February 28, 2017
BOARD OF COUNTY COMMISSIONERS
ORANGE COUNTY, FLORIDA
Y17-731-CC / ADDENDUM # 3
WITTENSTEIN COTTAGE ADA UPGRADES AND RENOVATIONS
Bid Opening Date: March 7, 2017

This addendum is hereby incorporated into the bid documents of the project referenced above. The following items are clarifications, corrections, additions, deletions and/or revisions to and shall take precedence over the original documents. Underlining indicates additions, deletions are indicated by ~~strike through~~.

File Name
Q:\PROJECT FILES\2016\2016-066 Wittenstein House Reno\Drawings\1600-E101-2016066.dwg

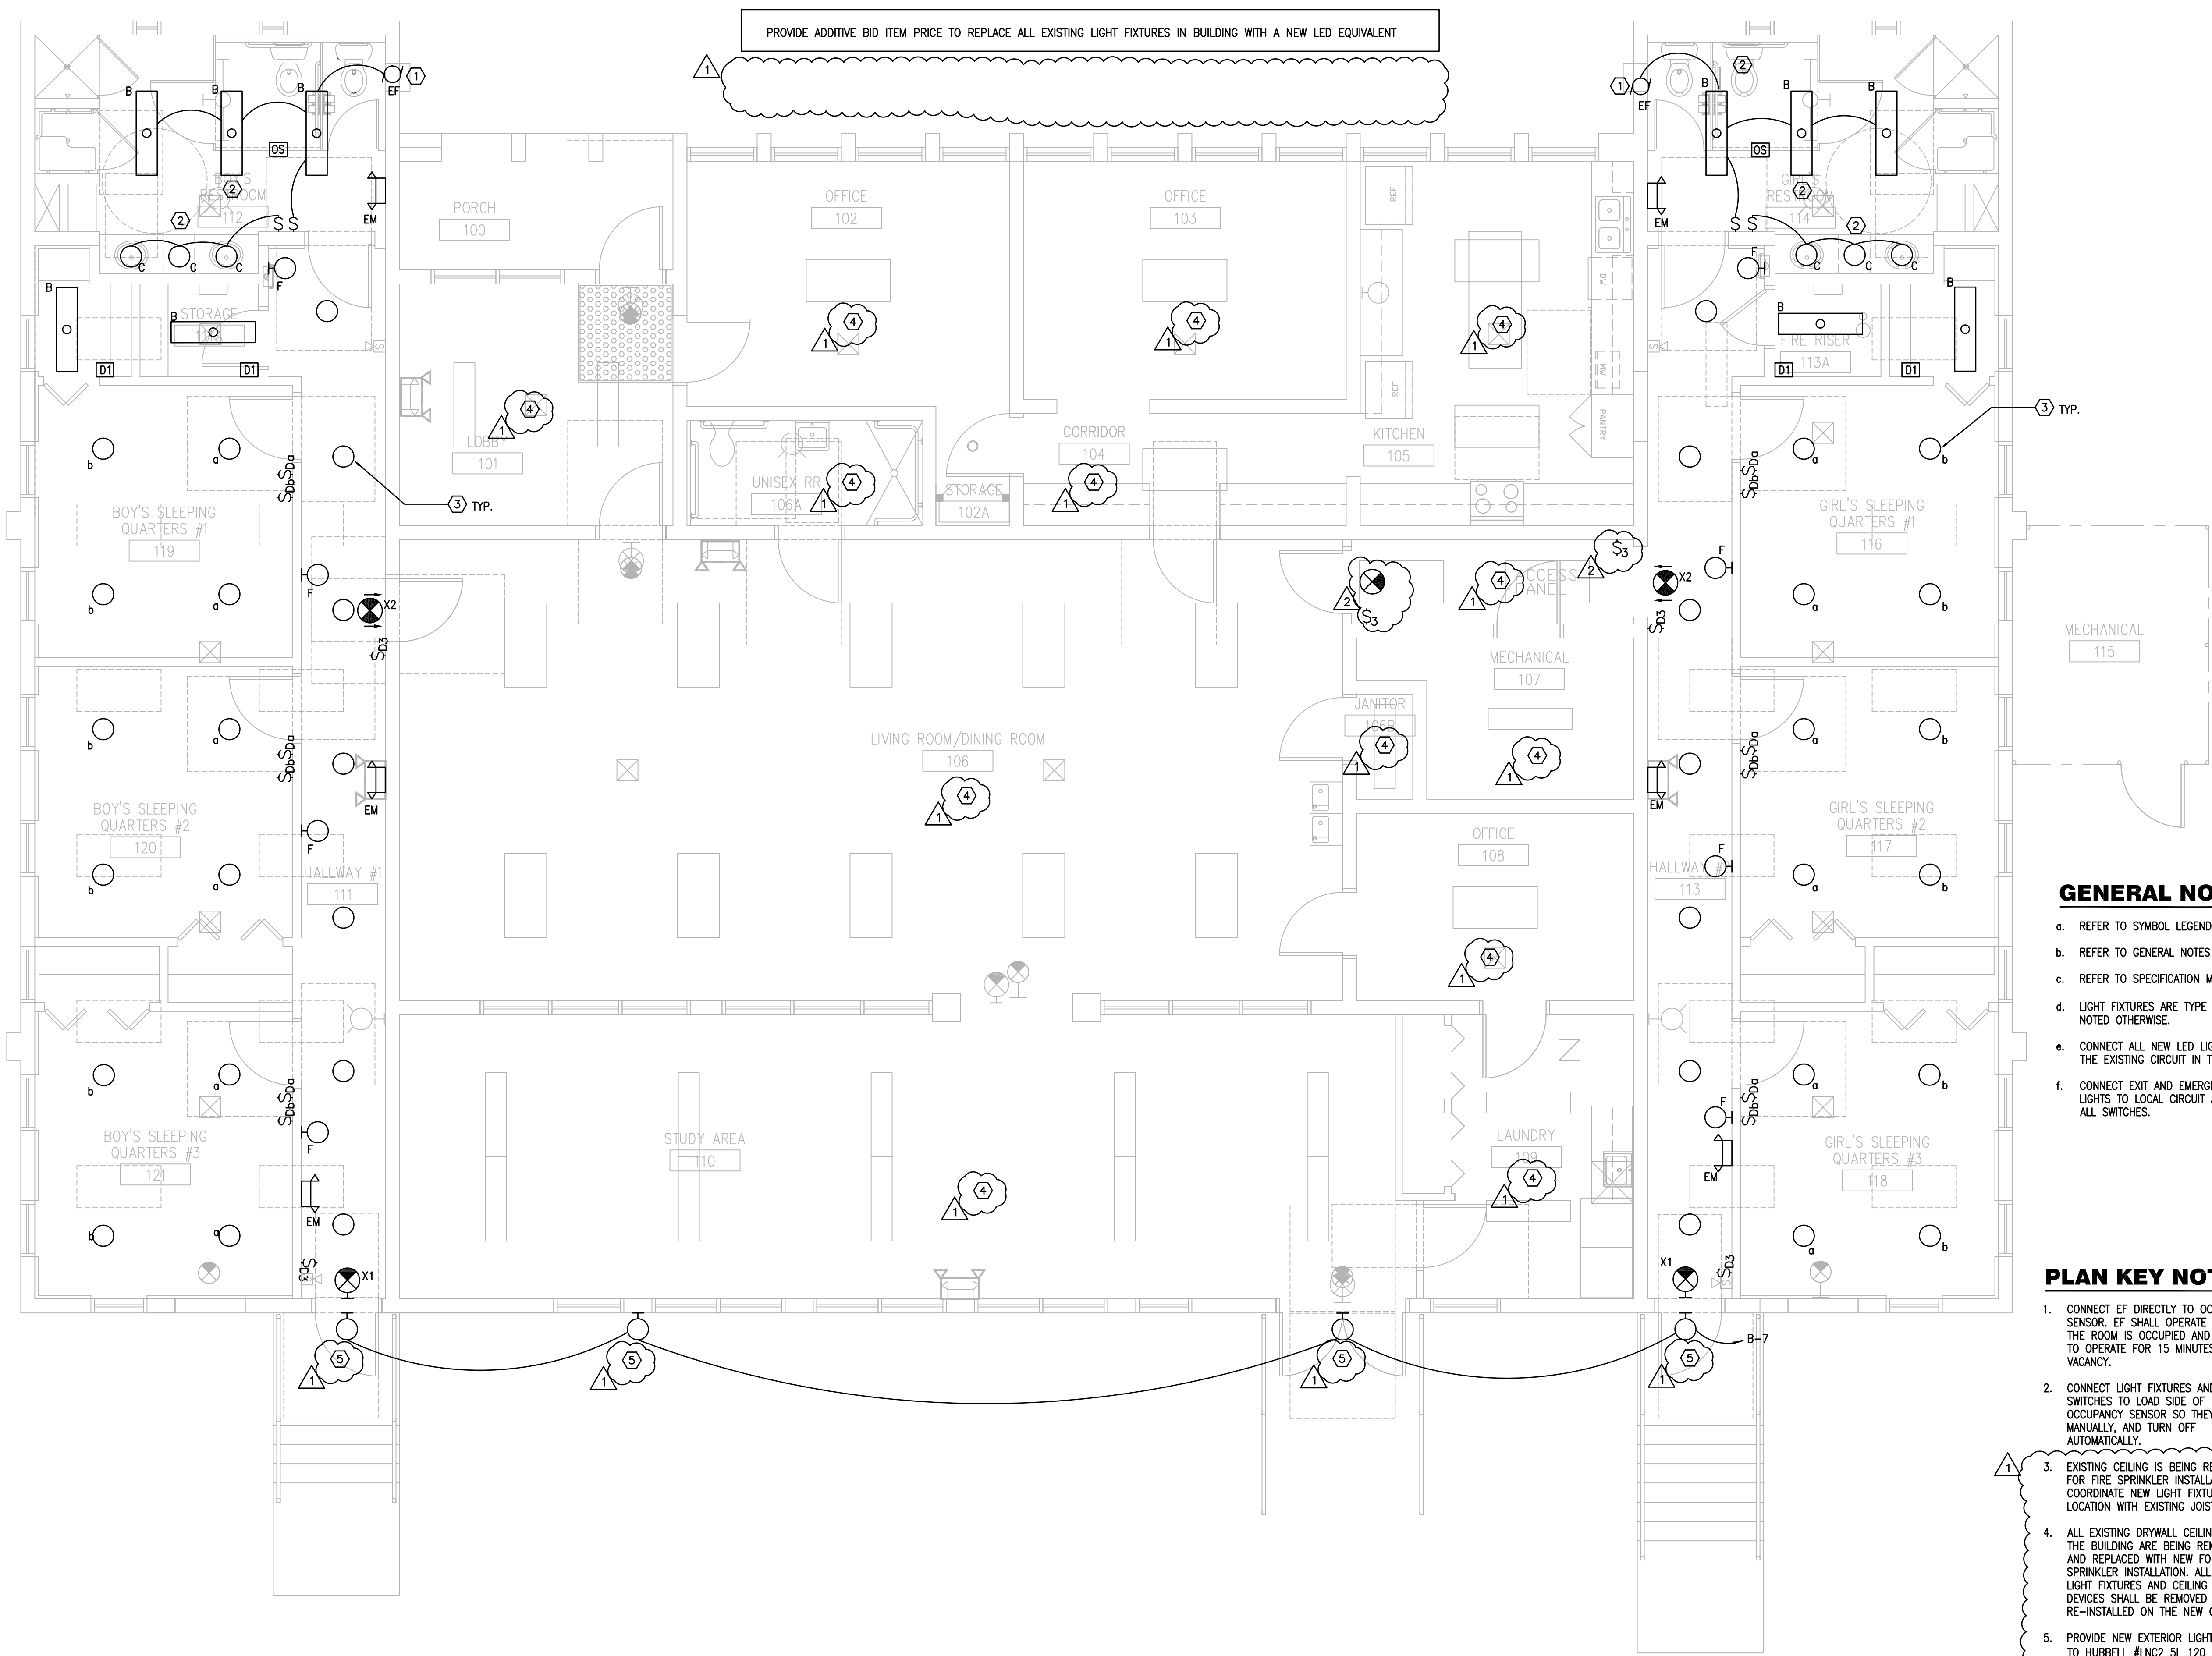
13. Question: Taking into consideration the General Notes D on sheet E1.01, it is an assumption that the lights placed outside in the back of the building will be Type A fixtures. I would like to confirm, considering that they are similarly presented as the Type F Fixtures in the hallways, that the outdoor lights will be Type A Fixtures.

Answer: Per attached Revised Sheet E101, Plan Note #5 the outdoor fixtures shall be equal to Hubbell #LNC2 5L 120 4K 3 PC.
